Access Compliance Report

Public Rights-of-Way

(Curb Ramps)

Intersection ID: 51721	Main Street: PROVIDENCE_RD_WEST	Cross Street: BALLANCROFT_PY	Location: NW
ADA ID: 6A9DA3FF6CA5	Ramp Type: Perp	Initial Pass/Fail: Fail	Overall Compliance: No
Severity Score: 1.25			
Codes/Mitigation Info/Possible Solution		Field Measurements/Component Compliance

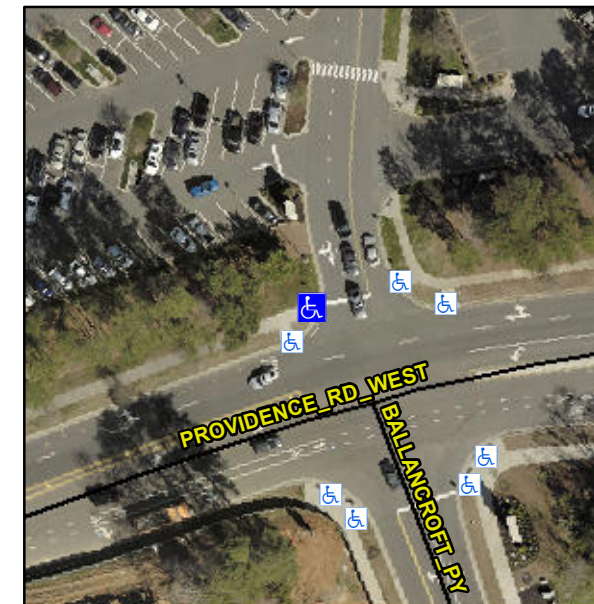
Compliance	Description	Data	Compliance	Description	Data
N/A	Ramp Length (in)	168.0	Yes	Ramp Slope (%)	5.9
Yes	Ramp Width (in)	74.0	No	Ramp XSlope (%)	3.5
N/A	Flare Type LT	N/A	N/A	Flare Type RT	N/A
N/A	Flare Slope LT (%)	N/A	N/A	Flare Slope RT (%)	N/A
N/A	Flare Traversable LT?	N/A	N/A	Flare Traversable RT?	N/A
N/A	Landing Length (in)	N/A	N/A	DWS Provided?	N/A
N/A	Landing Width (in)	N/A	N/A	DWS Contrast?	N/A
N/A	Landing Slope (%)	N/A	N/A	DWS Length (in)	N/A
N/A	Landing X Slope (%)	N/A	N/A	DWS Full Width?	N/A
N/A	Landing Curb? (Y/N)	N/A	N/A	DWS Offset (in)	N/A
N/A	Shared Landing?	N/A			
N/A	Gutter Ponding?	N/A	N/A	Gutter Slope (%)	N/A
N/A	Gutter Lip Ht (in)	N/A	N/A	Gutter X Slope (%)	N/A
N/A	Painted X Walk1?	No	N/A	Painted X Walk2?	N/A
	X Walk 1 Direction	To E		X Walk 2 Direction	N/A
N/A	X Walk 1 Width (in)	N/A	N/A	X Walk 2 Width (in)	N/A
	X Walk 1 Slope (%)	3.2		X Walk 2 Slope (%)	N/A
	X Walk 1 X Slope (%)	4.0		X Walk 2 X Slope (%)	N/A

Remove & Replace Entire Ramp.

R304.5.3
